MISSISSIPPI POWER & LIGHT COMPANY

SUBJECT: Grand Gulf Nuclear Station
Units 1 and 2
Docket Nos. 50-416 and 50-417
License No. NPF-13
File: 0260/L-860.0/M-018.0
TDI Diesel Generator, Supplemental
Information
AECM-84/0230

RESPONSES TO NRC UNRESOLVED ISSUES

FIGURE 1

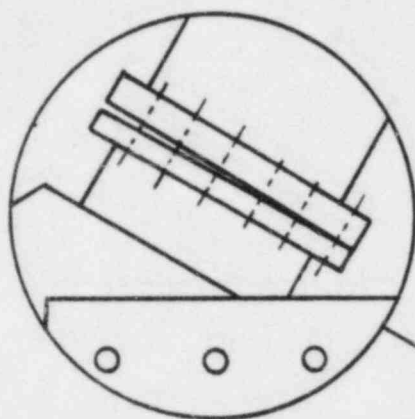
As part of the DR/QR program, LILCO recently discovered linear indications, using liquid penetrant testing methods, on the surface of the wrist pin bushings. These bushings are cast of bronze and are press fit into the connecting rod. The wrist pin attaches the piston skirt to the connecting rod with a .004 to .006 inch tolerance between the outside of the wrist pin and the inside mating surface of the wrist pin bushing.

FaAA examined representative samples of the bushings found with linear indications on both used and as received bushings. These examinations, utilizing liquid penetrant and scanning electron microscopy, on both used and as received bushings, revealed no differences in either crack surface morphology or liquid penetrant indications. These findings demonstrate that the indications found by liquid penetrant technique do not propagate as cracks. Furthermore, when the bushings were cut for sample removal, the sample piece sprung apart indicating a residual compressive stress on the inside surface of the bushing. This residual compressive stress together with the operational stresses (i.e., firing loads) would put the bushing in a state of triaxial compression. FaAA also observed that the used bushing, which had shown a linear indication in the highly stressed zone, did not show any evidence of permanent deformation. The most highly loaded area of the bushing during operation is an arc of 15° on either side of the bottom of the bushing relative to the firing plane (the axial loading plane on Figure 1).

Since the indications have been diagnosed to be typical casting defects, it is reasonable to assume that a fraction of wrist pin bushings in service in TDI engines may show such indications. However, based on the experimental evidence and the state of stresses experienced by the bushing, it is very unlikely that these indications could propagate as cracks and fail under the expected service environment. In addition, there is no reported history of failure of these components in either nuclear or non-nuclear service.

NRC ITEM	DISCUSSION	RESOLUTION
3. Wrist Pin Bushings	a. MP&L has determined through analysis by FaAA that it is very unlikely that a failure of a wrist pin bushing could occur. There is no industry history of problems with these components in either nuclear or non-nuclear service.	a. Dye Penetrant check next refueling outage for cracks. b. Replacement of bushings found to be cracked. c. Perform elemental oil analysis for metals after every engine surveillance run. d. Batch traceability to lots compared to Shoreham, Comm. Peak, and Columbia are being investigated.

FIGURE 2

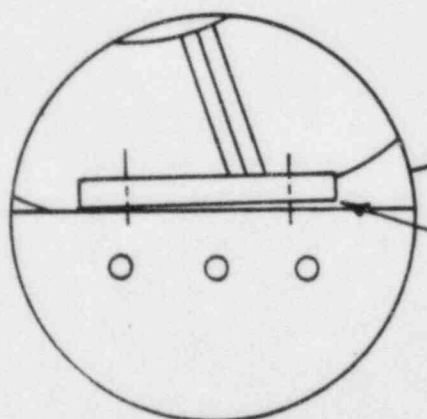
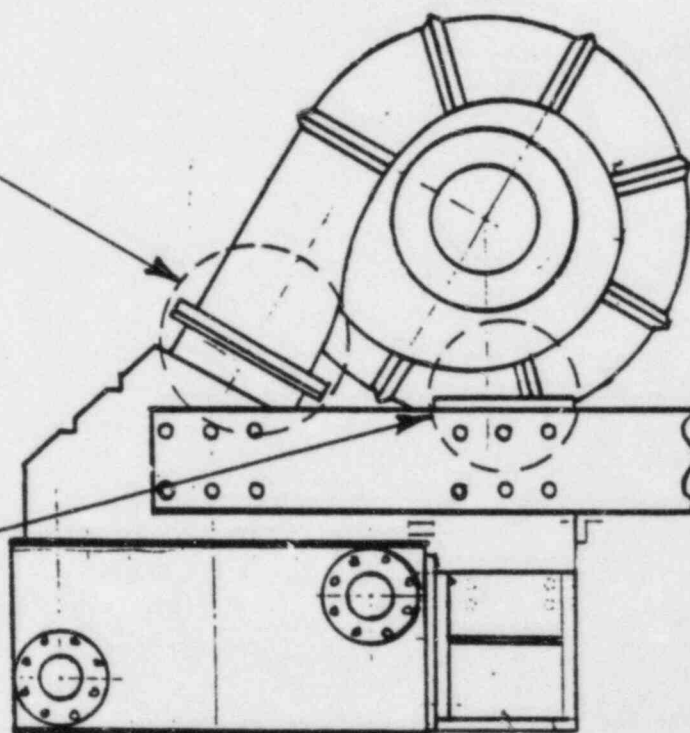
Original problems with supports and components adjacent to the Division I D/G left bank turbocharger have been attributed to a turbocharger that had exhibited signs of unusual vibration. This turbocharger was replaced with a spare turbocharger in August of 1983. Both Division I D/G turbochargers were replaced following the D/G fire in September of 1983 because they were located in the fire area and their ability to carry out their design function was in question. Recurring problems with alignment on the left bank turbocharger were experienced following the replacement in August of 1983. This was corrected in February of 1984 when an extensive maintenance effort was undertaken to correct the alignment problem. Following this effort the Division I D/G completed an 100 run (32 hours @ 100%, 68 hours @ 75%) with no further problems.

The alignment problems with the turbochargers are partially a function of the custom fit arrangement of the turbocharger with the flanged connections on the mating piping and apparatus. Each engine supplied by TDI has slightly different piping due to the fact that it is hand built. The specific problems encountered with the left bank turbocharger on the Division I D/G was the misalignment of the turbocharger and intercooler mating flanges. These flanges were misaligned such that if the flanged connection was tightened down, the turbocharger would cock on the mounting pedestal approximately 30 mils (Figure 2). This problem was attacked several times before a satisfactory conclusion was achieved. Finally, TDI recommended that (1) the intercooler flange be cut, (2) the turbocharger bolted down, (3) the intercooler flange be bolted to the turbocharger, (4) the intercooler flange tack welded to the intercooler, (5) the turbocharger removed, (6) the intercooler flange rewelded, (7) the turbocharger remounted, (8) the turbocharger bolted down, (9) the intercooler flange bolted up, (10) the turbocharger mounting bolts removed, (11) the mounting plate checked for clearances, (12) the turbocharger remounted, (13) a maintenance run performed, (14) the turbocharger mounting bolts removed, (15) the mounting plate rechecked for clearances, (16) the mounting bolts and reinstalled.

At the end of this process the engine was tested for 100 hours and the mounting clearances rechecked. The final conclusion was that the problem has effectively been solved. The final clearances were 0,0,0,3 mils on each of the four corners of the mounting plate. This is considered acceptable and the successful completion of the 100 hour run demonstrated that the problem has been solved.

6. Turbocharger		
a. Alignment	a. Was an external misalignment problem.	a. Clarification and update to Feb. 20 letter in response to NRC April 11 letter.
